RE: ROSELANDS SHOPPING CENTRE PLANNING REVIEW PANEL COMMENTS

RE: ROSELANDS SHOPPING CENTRE PLANNING REVIEW PANEL COMMENTS

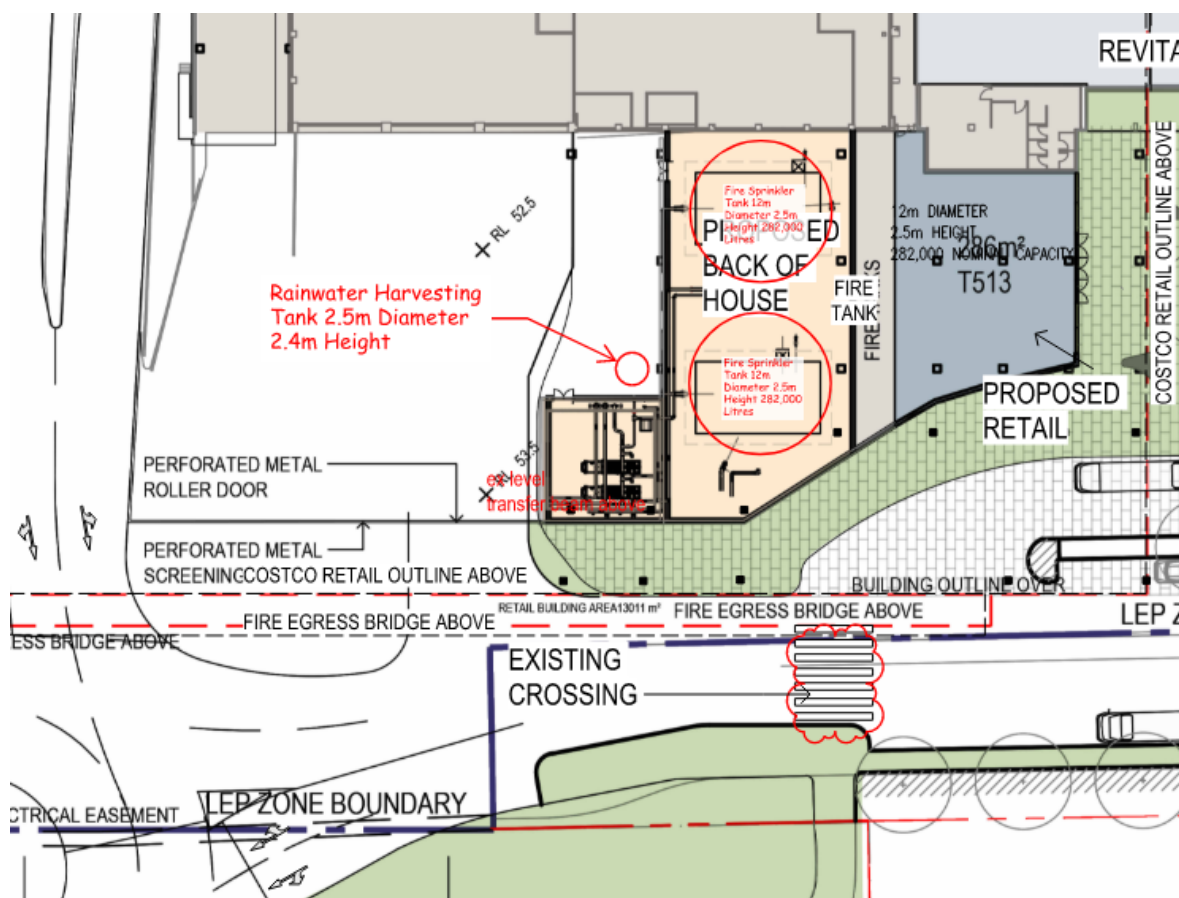
iv) The Panel notes and supports the significant quantity of bio-filtration zones within the new car parking areas. However, the Panel recommends including a clear catchment and reuse strategy for the significant new roofed area of the development.

PV panels can potentially be incorporated into the development area roof design.

The new roof catchment area(s) can potentially be collected and directed to a rainwater harvesting tank which can be used for landscaping and/or toilet flushing within the new development area.

This strategy will be developed in conjunction with the Civil design to ensure that the rainwater harvesting tank overflow is directed to the relevant stormwater management catchment area.

The proposed rainwater harvesting tank can be located adjacent to the fire sprinkler Pump Room:

Fire sprinkler test water can be recycled back to the fire sprinkler storage tanks.
